Project	IEEE 802.16 Broadband Wireless Access Working Group < http://ieee802.org/16 >	
Title	Flow charts merging for the BS initialization procedure	
Date Submitted	2006-09-17	
Source(s)	Wu Xuyong, Huawei Huawei Industrial Base, Bantian, Longgang, Shenzhen 518129 P.R.C	Voice: +86-755-28972327 Fax: wuxuyong@huawei.com
Re:	80216h-06_021: Third Working Group Review: P802.16h Working Document (2006-08-10)	
Abstract	To merge 2 flow chart figure h8/h9 according to the 44 th meeting.	
Purpose	To consolidate the working document.	
Notice	This document has been prepared to assist IEEE 802.16. It is offered as a basis for discussion and is not binding on the contributing individual(s) or organization(s). The material in this document is subject to change in form and content after further study. The contributor(s) reserve(s) the right to add, amend or withdraw material contained herein.	
Release	The contributor grants a free, irrevocable license to the IEEE to incorporate material contained in this contribution, and any modifications thereof, in the creation of an IEEE Standards publication; to copyright in the IEEE's name any IEEE Standards publication even though it may include portions of

Figure h8 — Initialization procedures — BS

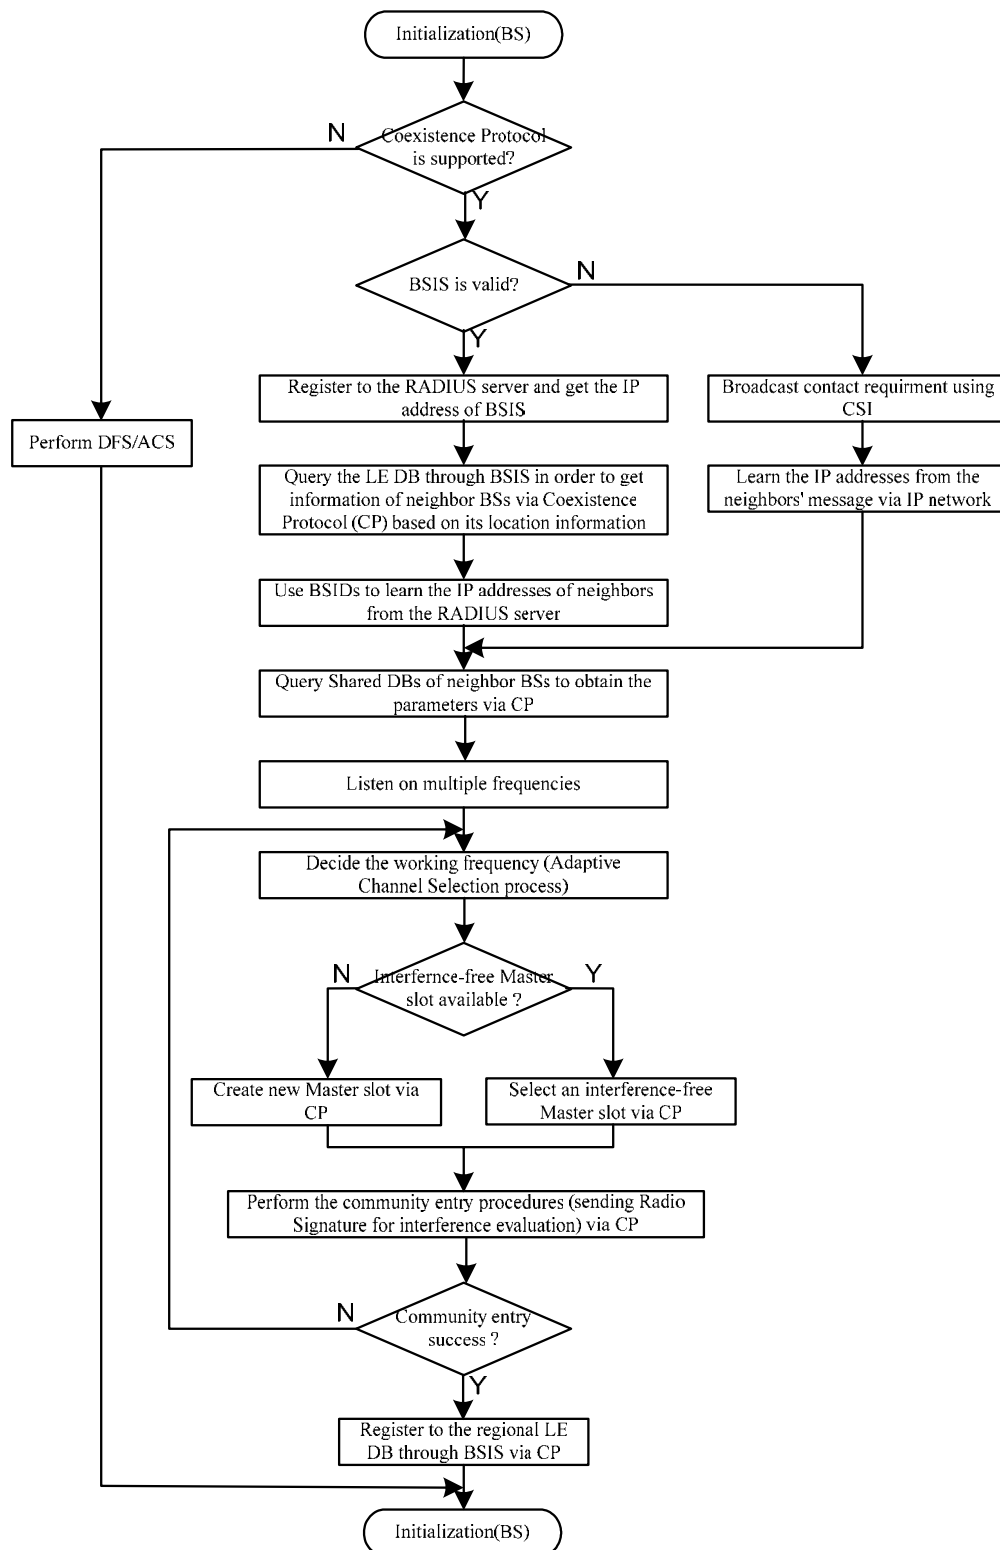
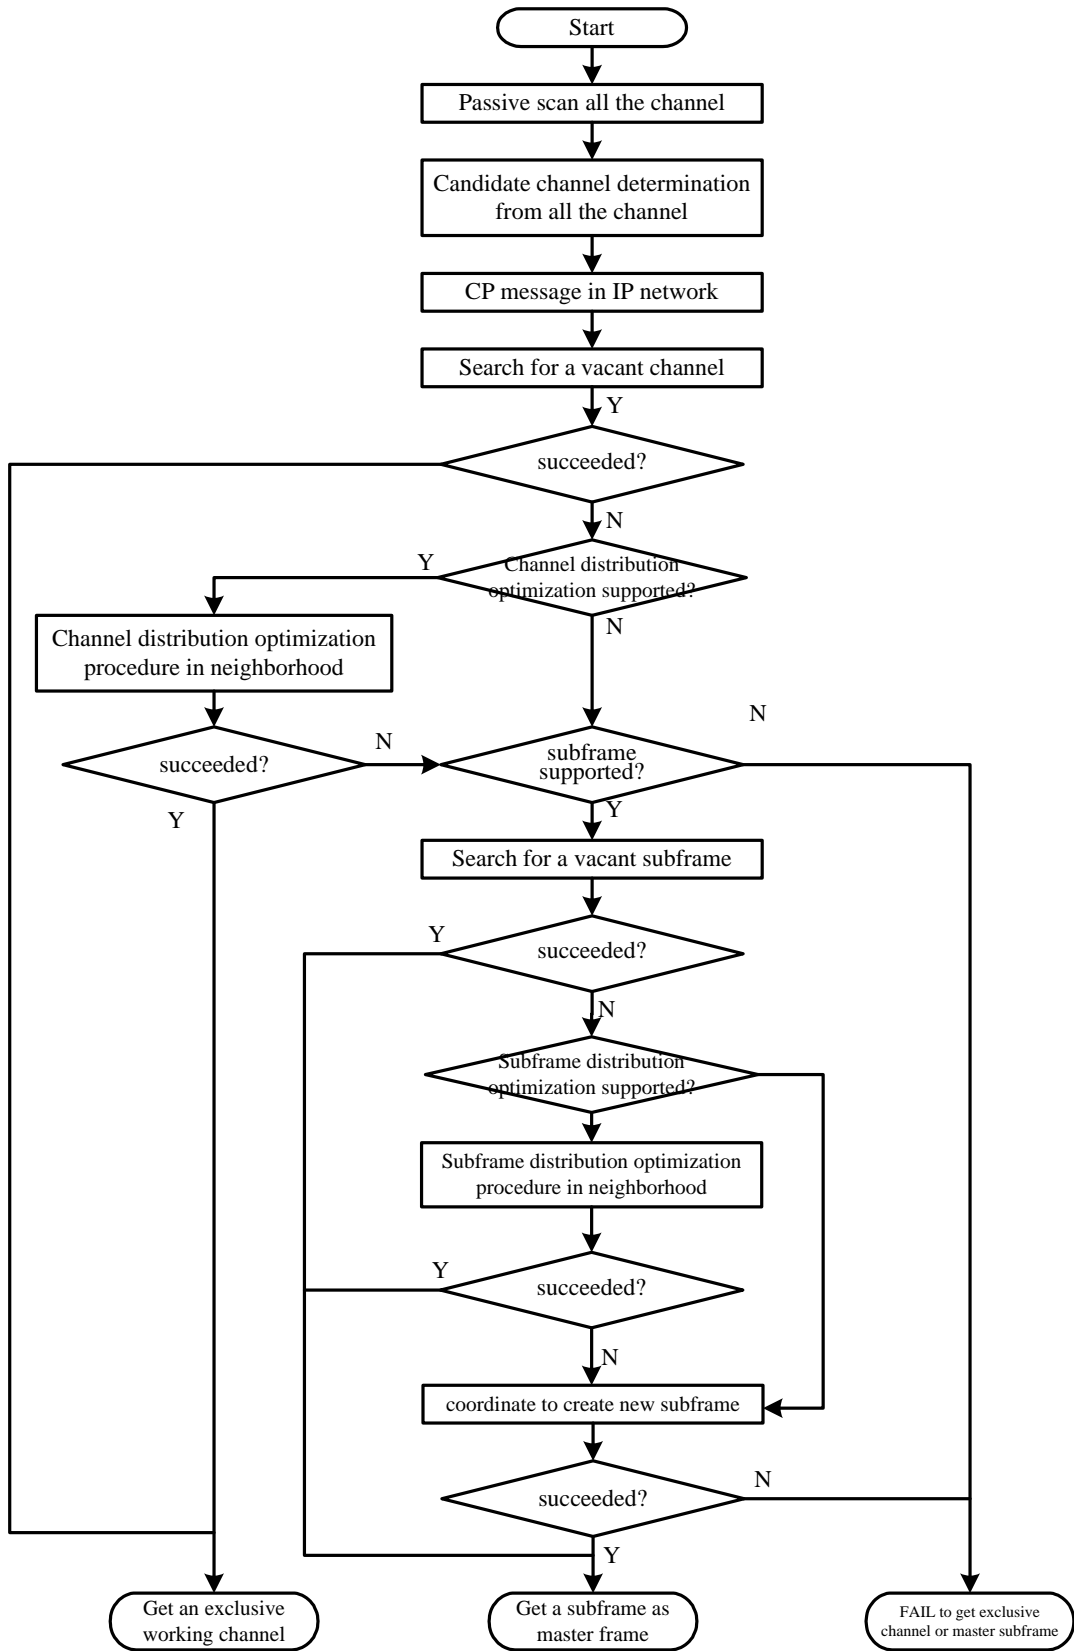
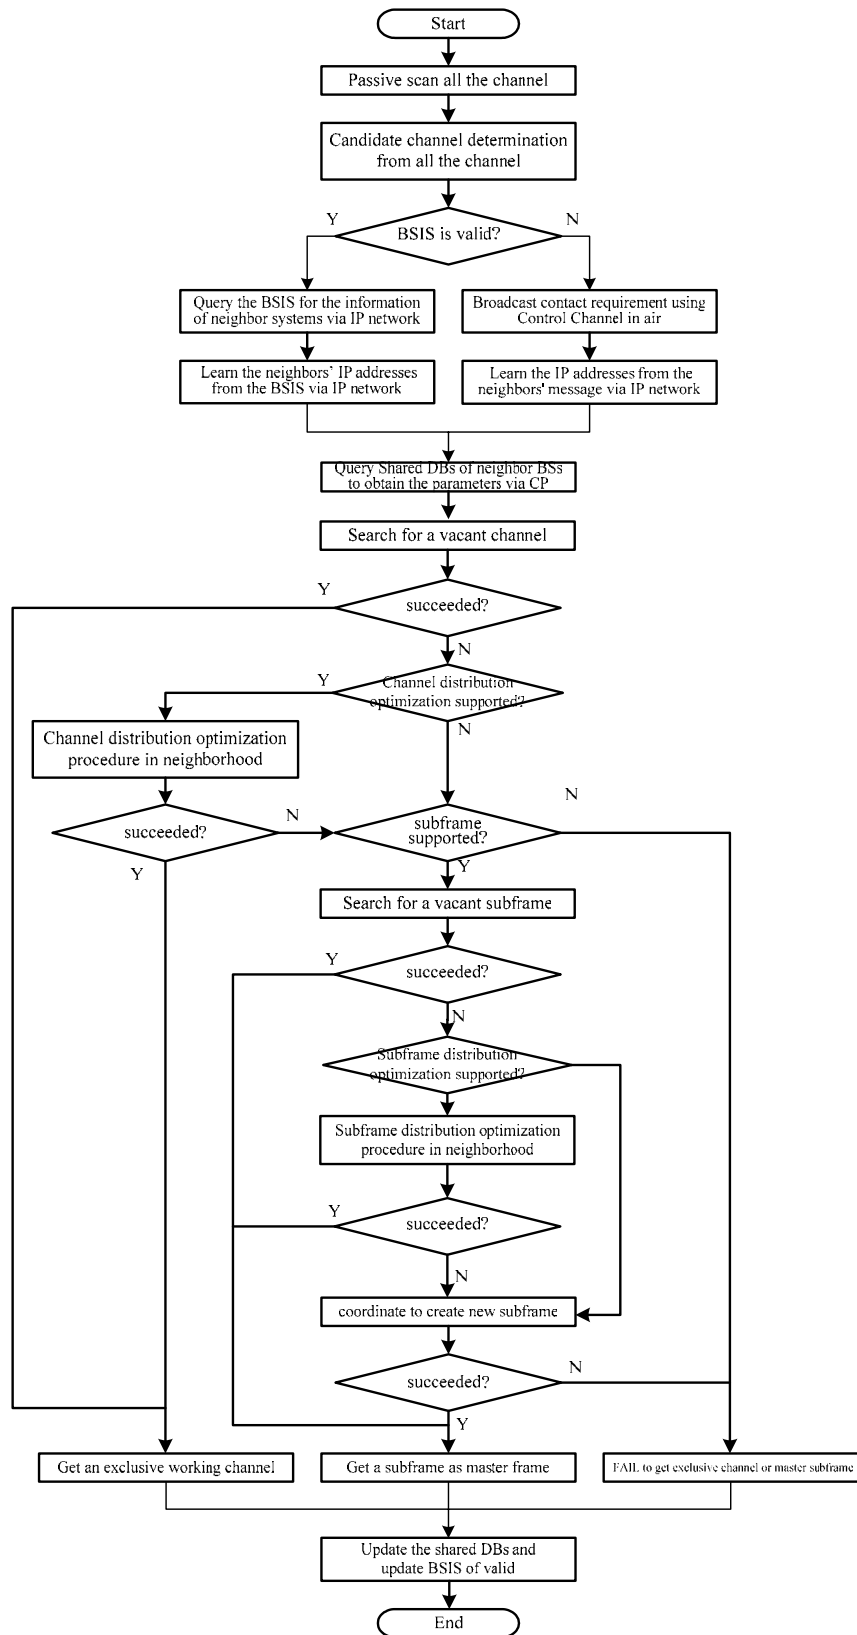
There are 2 flow charts inside 802.16h-06_015r1 working document illustrating the BS initializing procedure. They are somehow or other overlapping and redundant with each other.

This contribution is to merge these two figure into one and trying to keep all useful illustration inside, according to the action item as LE TG resolution in meeting 44th.
